The City of New York
Community Board 8 Manhattan
Parks and Waterfront Committee
Thursday, October 9, 2025 - 6:30PM
Conducted remotely on Zoom.

Resolution for Approval:
Item 2: Approval of the revised plan for the reconstruction of 24 Sycamores Park

Item 2: Presentation of a revised plan for the reconstruction of 24 Sycamores Park by the Parks Department.

The plan below was presented at the previous Parks and Waterfront Committee meeting. As a result of the suggested changes, the Parks Department is making a new revised plan:

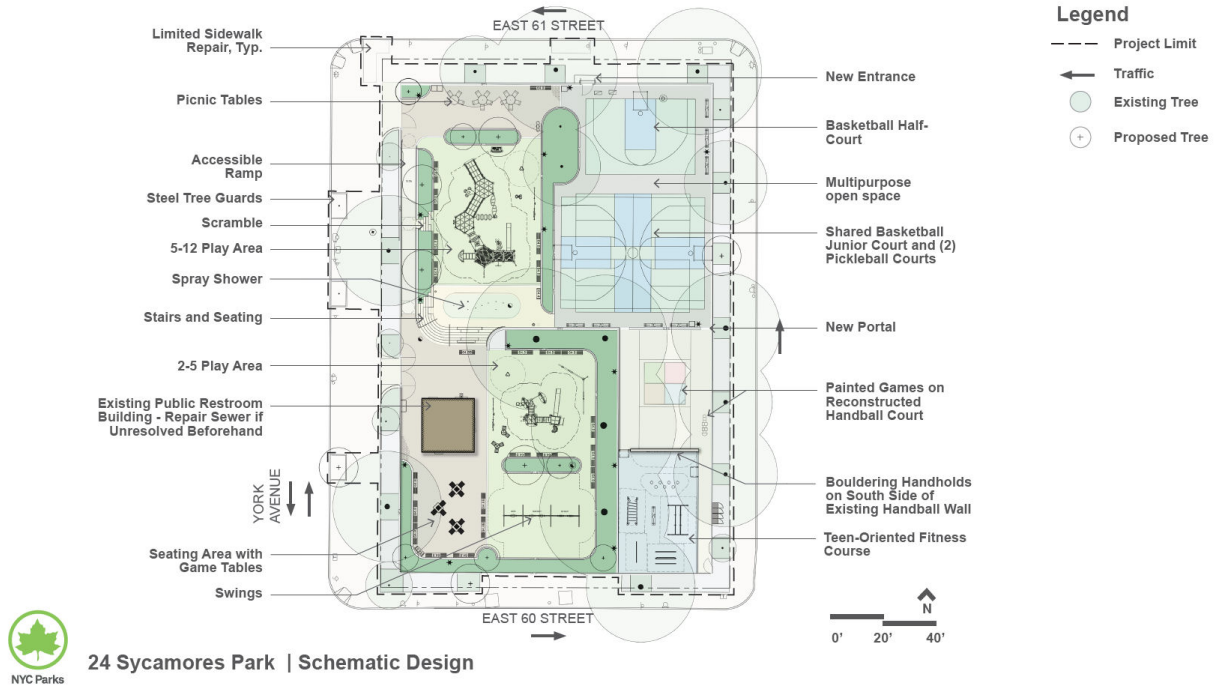
- We strongly support the shared space with the basketball and pickleball superimposed on one another, given the existing positive interactions and cooperation between these user groups at the park. However, we recommend that the pickleball courts be turned in the north/south direction so that one basketball court and one pickleball court can be used at the same time. Parks agreed to look into the feasibility of this suggestion and to paint the lines on the courts with contrasting colors so that each sport will be clearly delineated. They also agreed to show us the changes. (If the drawing is ready by the full board meeting on October 22nd, they will forward it to Community Associate Jon Kraus at the board office for the meeting.)

- Parks should work with the pickleball group to provide a storage container and location for pickleball nets and equipment.
- We would like the Parks Department to install wire hooks on the 16-foot fence with baskets for pickleball paddles.

- We request Parks review the upper-level arrangement of the tables and chairs and, if possible, add an additional swing.
